RE: RESPONSE TO SUBMISSIONS - DA 10646 for SEPP 64 ADVERTISING SIGNAGE PROPOSED AT SUSSEX STREET, SYDNEY

This letter has been prepared by Ethos Urban on behalf of Sydney Trains in response to the submissions received for DA 10646 which is currently under assessment by the Department of Planning, Industry and Environment (DPIE) and is part of a series of Crown Development Application's (DA) under Part 4 Division 4.6 of the *Environmental Planning and Assessment Act 1979* (EP&A Act) submitted to the DPIE.

Figure 2 Existing view from Level 2 (Viewpoint 1)

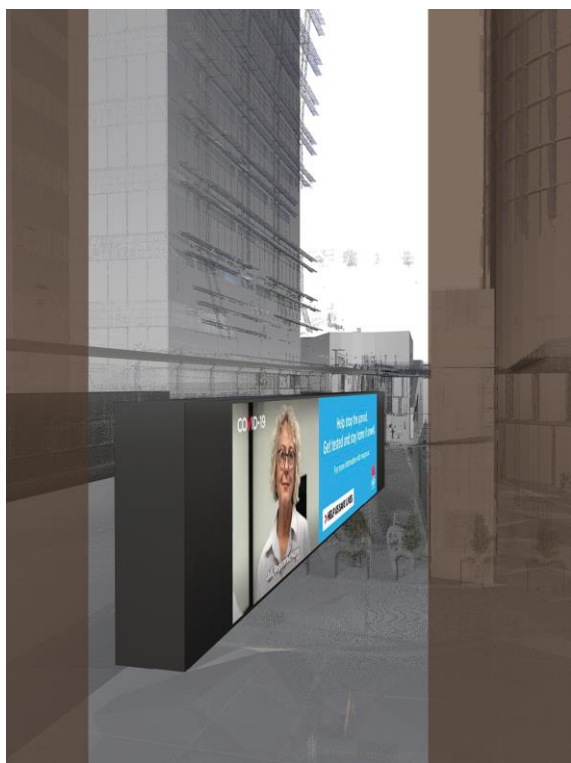
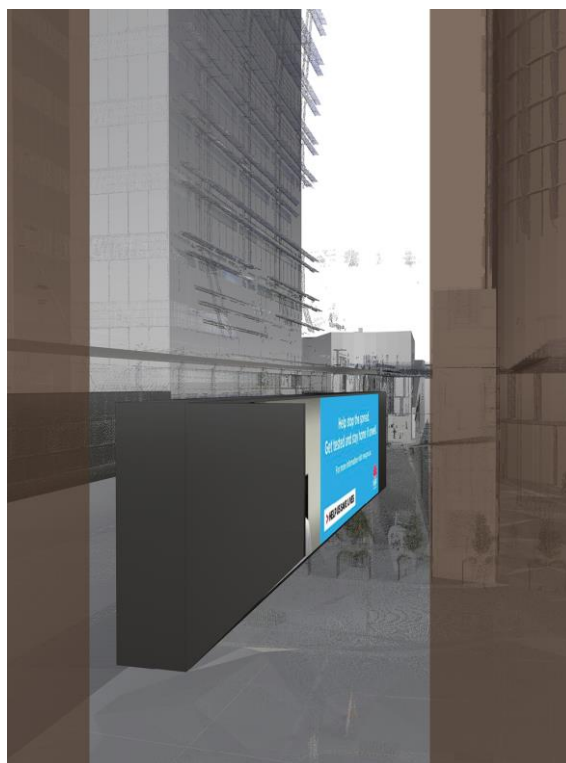
Public Submissions (agglomerated by topic trends)	
Visual Impact	
<ul style="list-style-type: none"> The signs will most adversely affect my 3 level residential unit comprising the upper 3 to 5 of my 5 level building at 26 Sussex Street. It will be an eyesore from all of my western facing windows. These windows are the only ones to receive direct sunlight and the sign would constitute a major obstruction to the outlook from all these windows. The sign will adversely affect the amenity of the area and make my premises less attractive to customers. The huge northern sign is less than 9 metres horizontal distance from my shopfront door 	<p>While the signs will result in a change to the locality, this is considered consistent with the ever evolving commercial nature of this part of the CBD which has undergone extensive changes over recent years with Barangaroo development as well as Wynyard Walk and other commercial developments resulting in a higher pedestrian activity and economic landscape, fuelling Sydney's position as a global city and being one of the major the economic power houses of the country. Additional view montages have been prepared using the City Model to provide an indication of the amended views from the property with the proposed shield. As seen in Section 3.2 Viewpoint 1 has been mitigated by the proposed shield, with Viewpoint 2 and 3 less impacted as a person is not looking directly at the sign when standing or sitting at the window. Persons would need to look down to view the sign, and as such, from these viewpoints, screening along the top of the sign is not considered warranted.</p>

Additional montages have been prepared noting the views provided by the submissions, to indicate the mitigation measure of the proposed 1.5m shield on the eastern side of the northern facing sign. As seen below, Viewpoint 1 has been mitigated by the proposed shield, with Viewpoint 2 and 3 less impacted as a person is not looking directly at the sign when standing or sitting at the window. Persons would need to look down to view the sign, and as such, from these viewpoints, screening along the top of the sign is not considered warranted.

Illumination	
<ul style="list-style-type: none"> The illuminated northern bridge sign will dominate the outlook from living room windows. It is also apparent that the sign will have a significant impact on light spill into the dwelling. The size, intensity of lighting and proximity of the sign are all incompatible with being located so near to an existing residence. This alone warrants outright refusal of the proposal. If the assessment is to continue, it is incumbent upon the applicant to address the extreme impact upon 26 Sussex Street in both the SEE and the Evaluation of Lighting Impact. The effect will be worse at night, when the bright, flickering sign will badly affect the amenity of the surrounding area. The situation would be worse at night, when flickering lights from the ever-changing sign will shine directly into my living areas, making them impossible to occupy without totally screening the western windows to all light and outlook. An ever-changing, flickering, deliberately bright and distracting digital sign will be intentionally distracting and annoying. It will not relate to the street lamps and will place the immediate area into dangerous shadow, particularly when people are temporarily 'blinded' by the brighter signs. 	<p>The proposed advertising signage does not exceed the illumination levels governed by SEPP 64. Whilst some light spill may affect the internal areas of the subject dwellings at the Sussex Hotel, the illumination impacts of this light spill will be minor. It is also important to note that under no circumstances will any flashing, pulsating or moving images will be portrayed on the advertisements. They will remain as static, illuminated images only and the illumination levels will only be noticeable after daylight hours. During daylight hours the illumination levels will not be noticeable and the sign will appear as a static board, similar to other advertising boards across the LGA. It is noted that the surrounding area has evolved overtime to be a high activity commercial hub where new developments and transportation projects have helped re-shape this part of Sydney into a new mixed-use, walkable and productive part of the Sydney CBD. Refer to the below additional assessment on illumination and the potential condition to be applied. Refer to the illumination report at Attachment B.</p> <p>The signage is not proposed to be a moving sign with no flickering, given its transition time of less than 0.1 seconds.</p> <p>In order to respond to the concerns raised, the signage design has been amended to incorporate a 1.5m shield along the signs eastern edge on the northern side of the bridge, to reduce the impact of the signage illumination. Refer to Attachment C for details.</p>
